**TOWN OF NEWBURGH  
PLANNING BOARD  
TECHNICAL REVIEW COMMENTS**

**PROJECT NAME: LZL EQUITIES INC. (DUNKIN DONUTS)**  
**PROJECT NO.: 14-02**  
**PROJECT LOCATION: SECTION 14, BLOCK. 1, LOT 43**  
**REVIEW DATE: 25 SEPTEMBER 2015**  
**MEETING DATE: 1 OCTOBER 2015**  
**REPRESENTATIVE: MERCURIO NORTON TAROLLI MARSHALL**

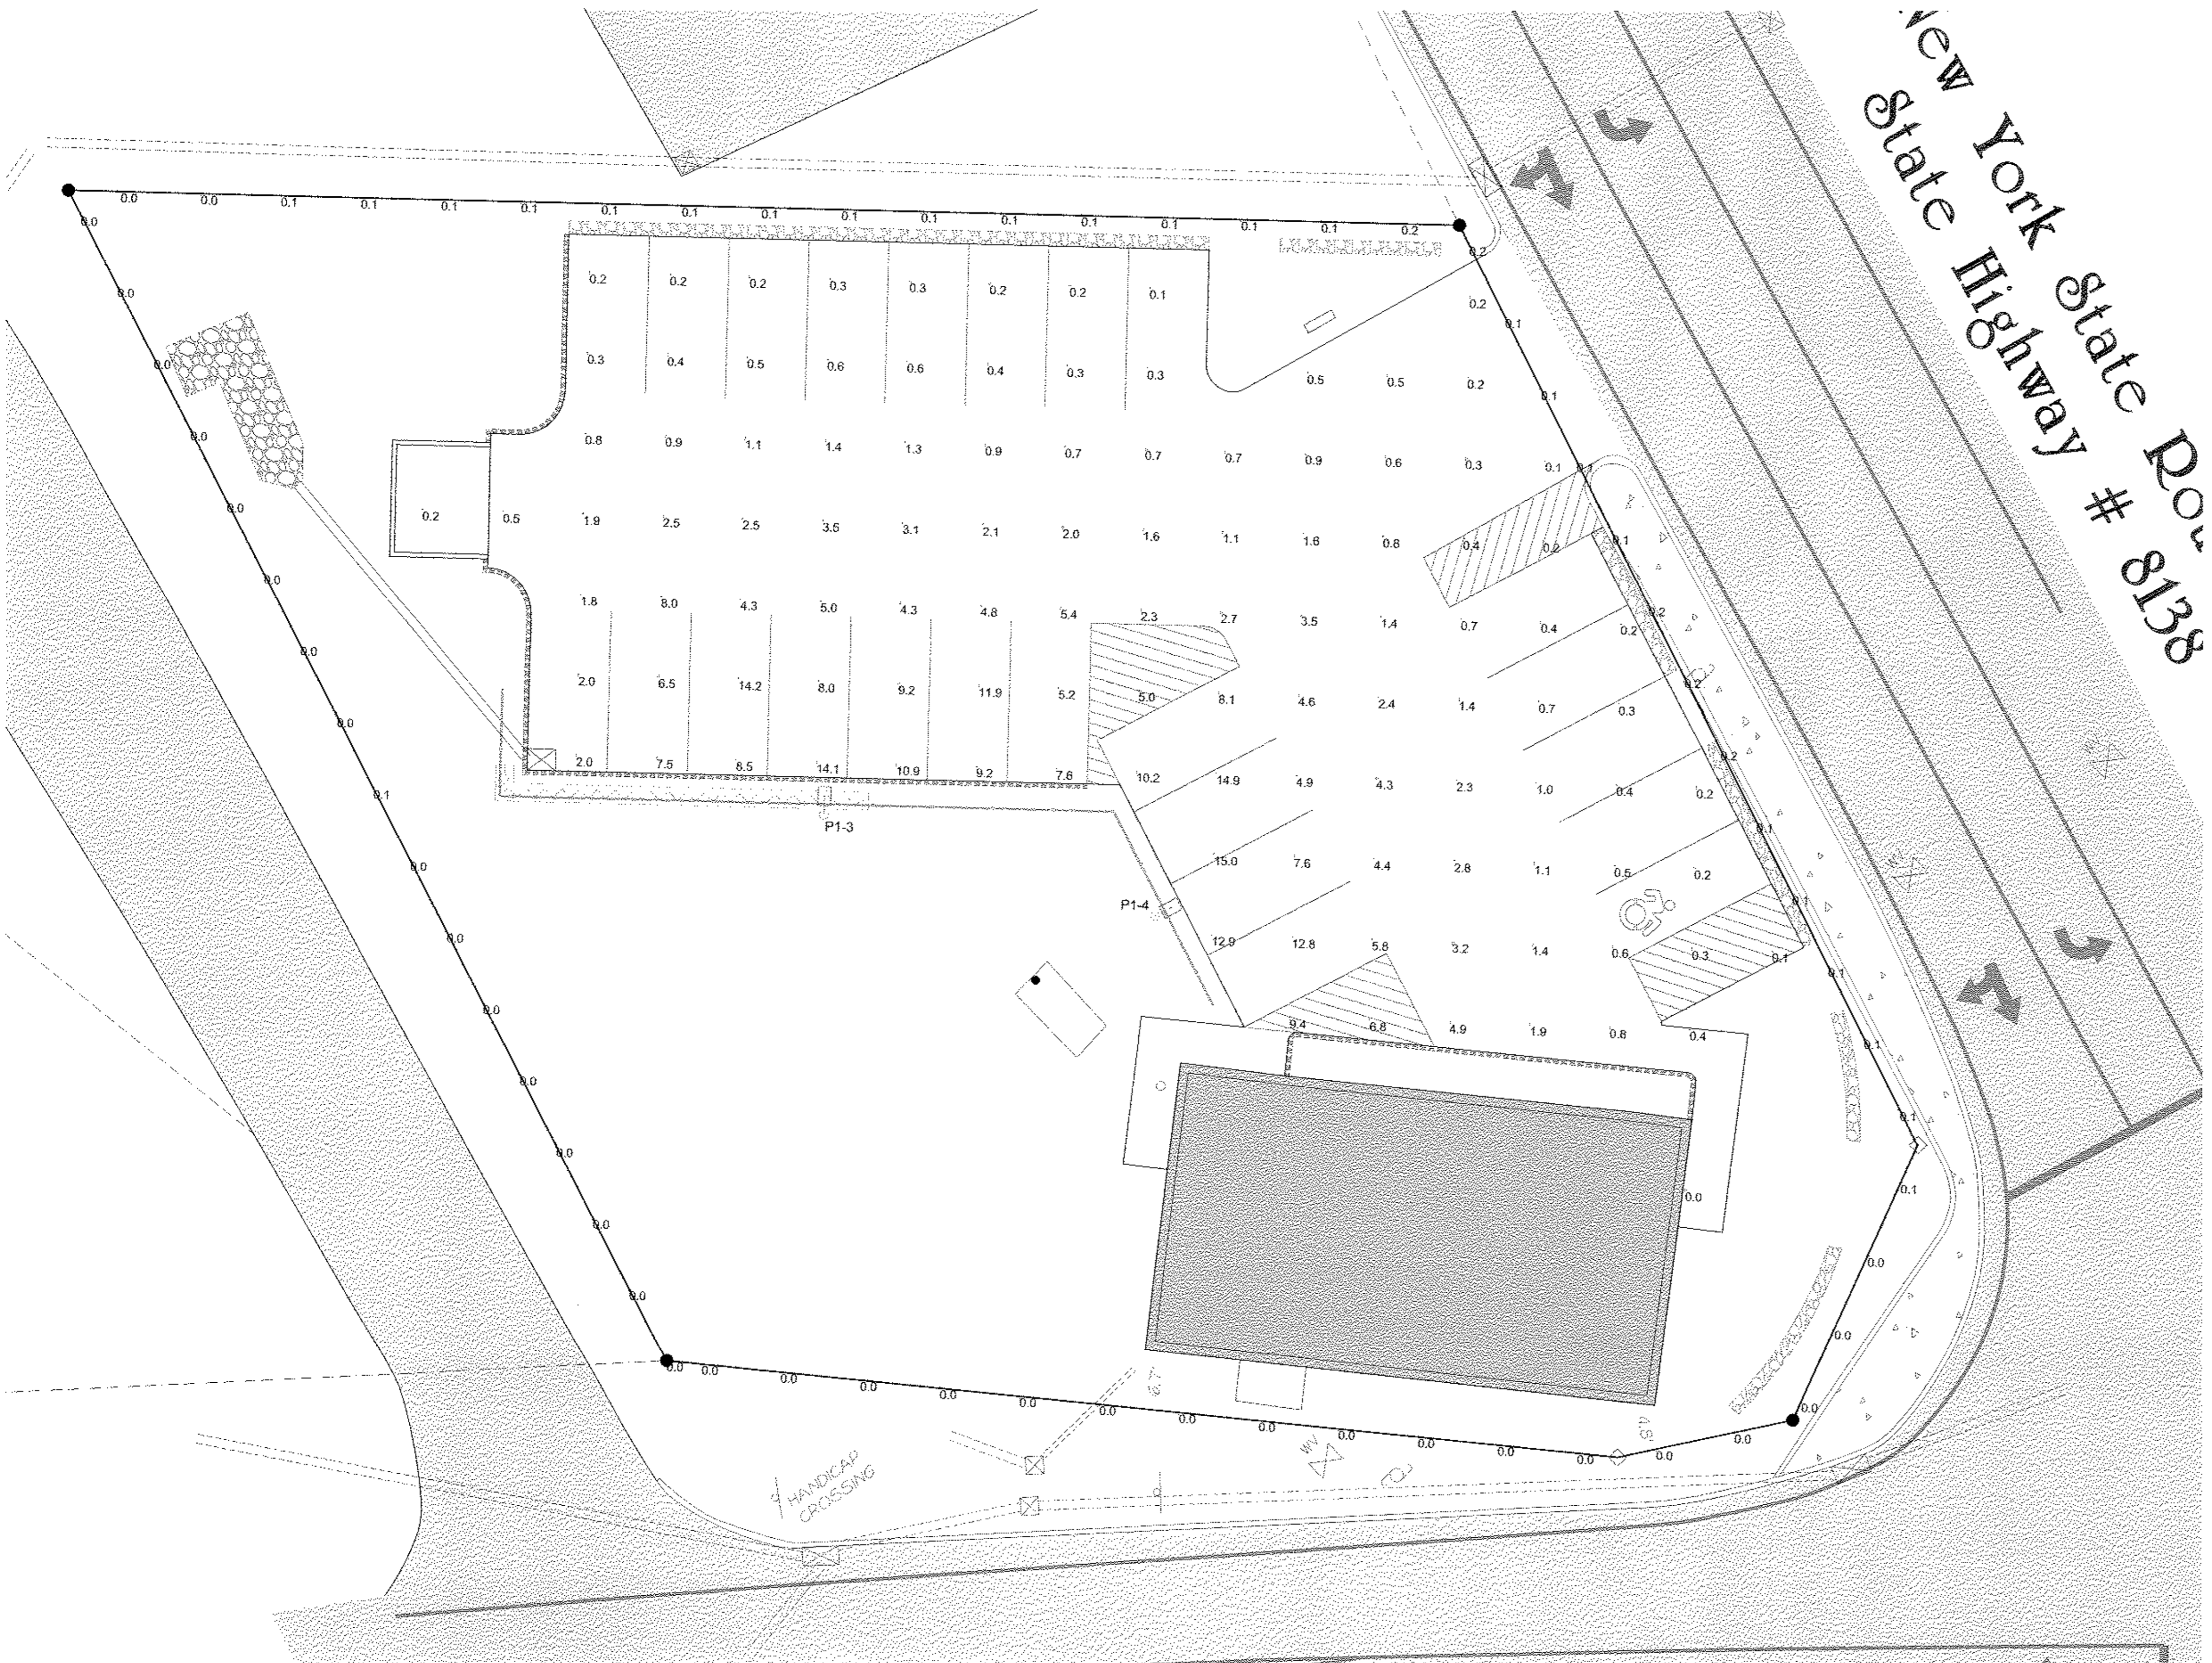
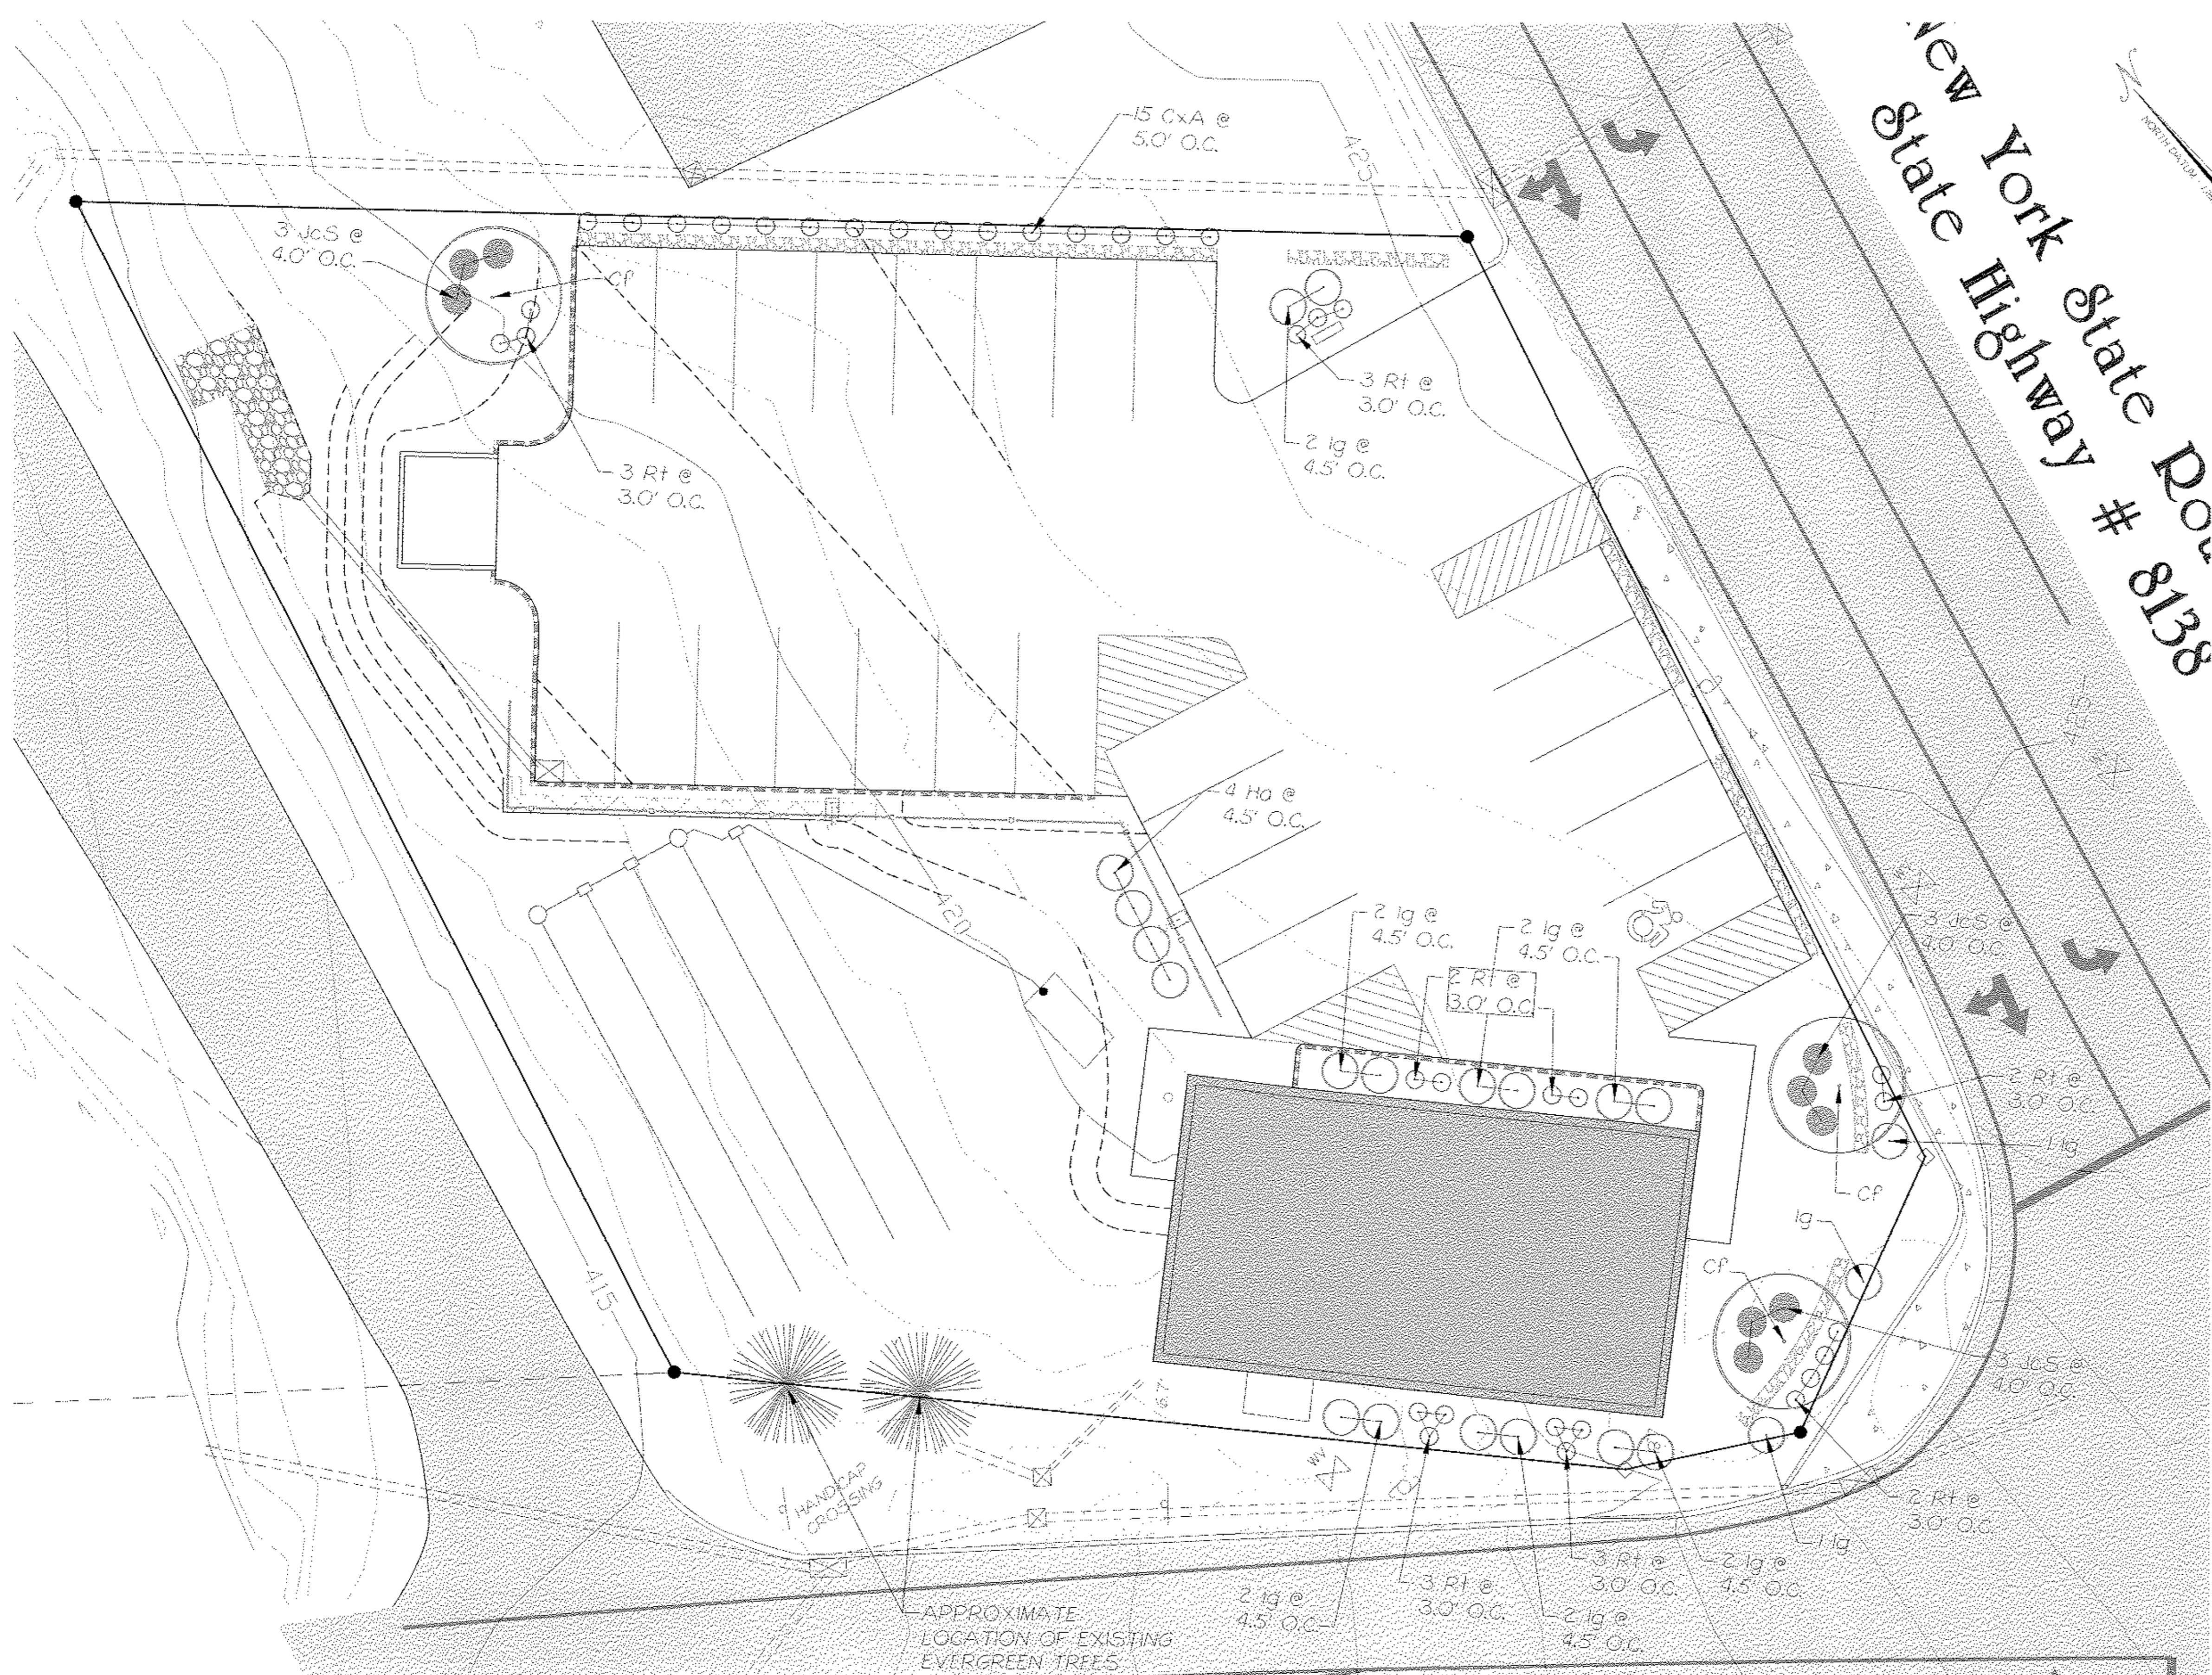
7. Erosion and sediment control details and the location of erosion control practices should be added to one of the plan sheets.
8. Revised landscape plan has been provided for the Planning Board's review. Planning Board's input on the plan should be received. It is noted that the dry laid stone walls continue to be proposed on the site to address parking in the front yard setback which is not in compliance with design guidelines.

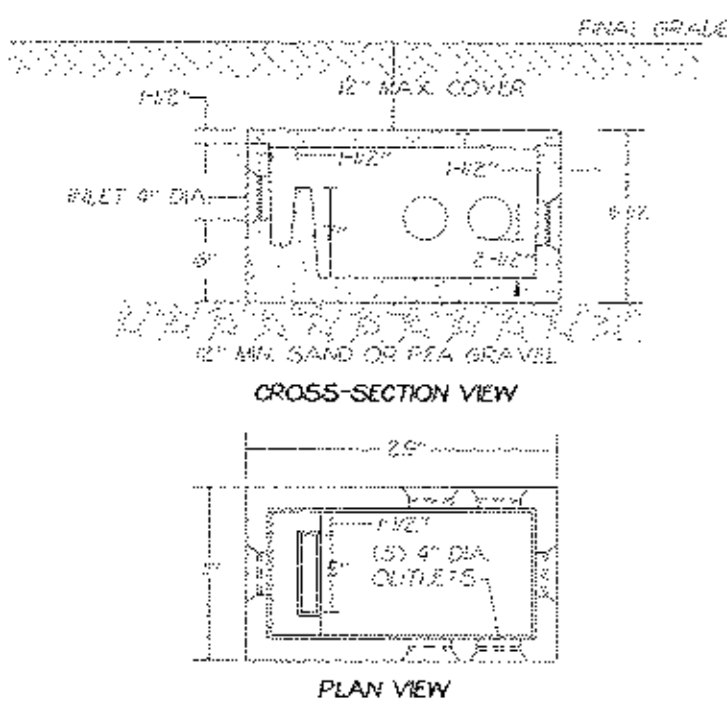
3. Septic plan identifies a shallow absorption trench system however, it appears conventional laterals are proposed.
4. Two new pedestrian scale light poles are proposed on the site. Lighting plan appears to be in compliance with Town of Newburgh lighting regulations.
